RE: North Texas Municipal Water District Permit Amendment Application (Permit No. 53A)

As a resident living, working, and visiting the area adjacent to the Lookout Transfer Station, I am concerned about the expansion as it is currently proposed. I have been affected by persistent odors, litter strewn about the park and the creek, and various heavy traffic noises.

SITE DIAGRAM

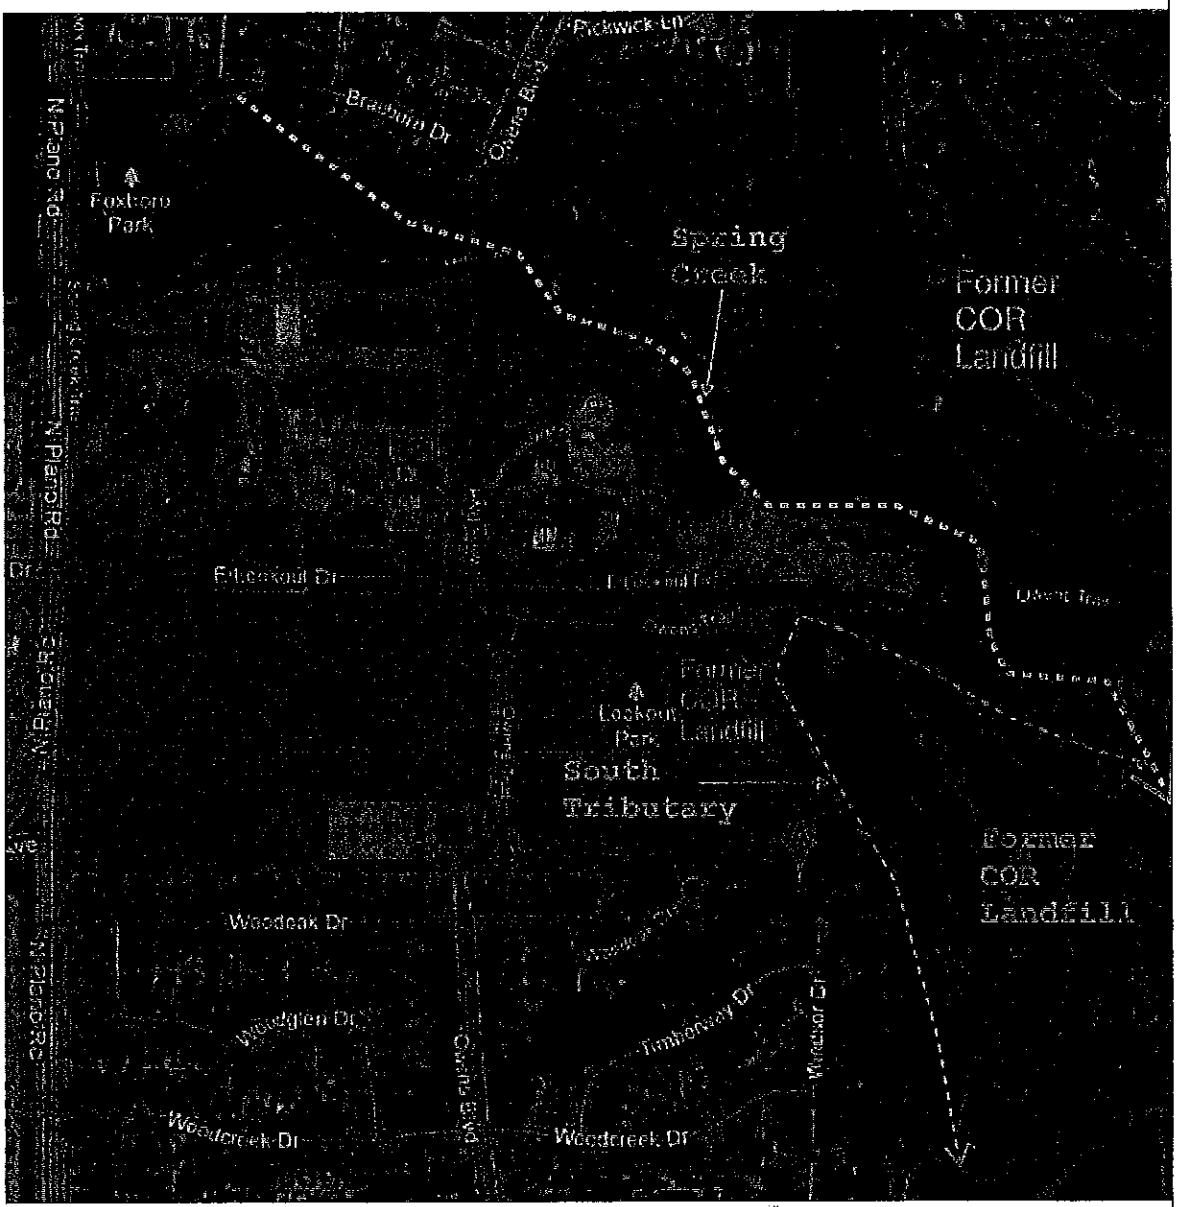
Residents have been able to obtain historical aerial photographs of the area back to 1995 in an attempt to determine the extents of the former COR landfill. However, a more thorough historical review may reveal that the current WTF and the proposed LTS are actually situated over the former landfill. According to statements made by the NTWD during the public meeting on October 9, 2012, no environmental or historical investigations have been performed or are planned.

Review of the site plan maps for the proposed LTS indicated the access and egress roads are insufficient to accommodate to the projected truck traffic. Sharp turns are required to maneuver into and out of the proposed facility that will cause truck traffic to stall, creating constant engine idling and revving. In addition, the 18 foot subsurface loading area of the proposed facility will cause constant engine revving noise as trucks climb up and out of this loading area. This noise will most certainly exceed the established Article XXII-B limits at the boundary of a Residential District, outlined below.

Spring Creek Photographs

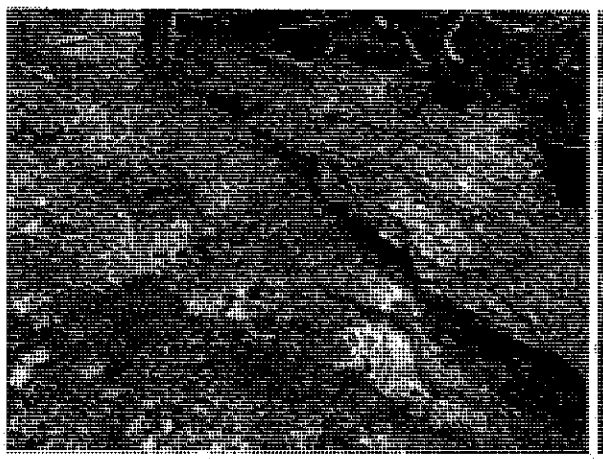
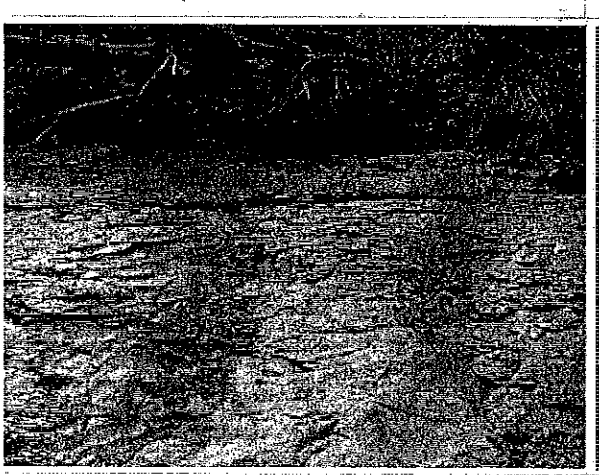
1. Northwest seep, stained wall (Spring Creek).

2. Sheen and staining from northwest seep, Spring Creek wall.

3. Seep origination on northwest Spring Creek wall).

4. Southeast seep, staining on Spring Creek wall.

5. Southeast seep, Spring Creek.

6. Sheen at southeast Spring Creek Seep.
